# Memo

**From:** (e)Transport Development Control Floor 1 North Rear Civic Offices Bridge Street Reading RG1 2LU  
**To:** Brian Conlon brian.conlon@reading.gov.uk  
**Date:** 17<sup>th</sup> December 2021  
**Re:** Consultation on Planning Application

**Application Number:** 200328

**Address:** Vastern Court Caversham Road Reading

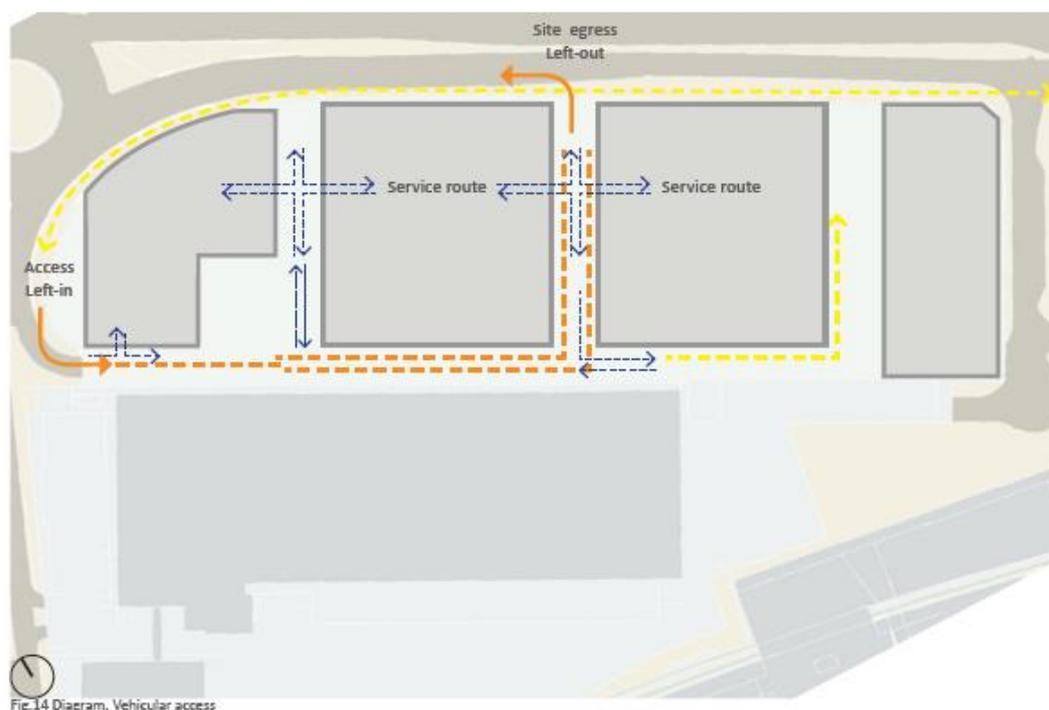
- It is proposed to serve Plot A via an access located in the north east corner of the building which will result in vehicles having to reverse along the pedestrianized route that leads to the existing signalized crossing on Vastern Road. This would be detrimental to Highway safety and cannot be supported. The proposal must therefore provide separate vehicle and pedestrianized areas not only adjacent to the loading area but along this north south route. This may be a secondary route but it will still play an important role in providing pedestrian and cycle access to the north.

and connects to a temporary access onto Trooper Potts Way. However, this should will need to be clarifies in more detail at reserved matters stage. In addition to this point I note paragraph 3.4 of the Design Code and in particular Figure 14, included below. These identify the provision of a controlled two-way service route along the southern boundary of Block C, this again would need more clarification and detail as to how this would be controlled, who would have access and how vehicles would turn so that vehicles are not reversing along a pedestrianized route as this will result in a fundamental objection.

Overall the Highway Authority are happy that the servicing of the site can be dealt with by way of a condition that requires specific servicing strategies for each phase as it progresses.
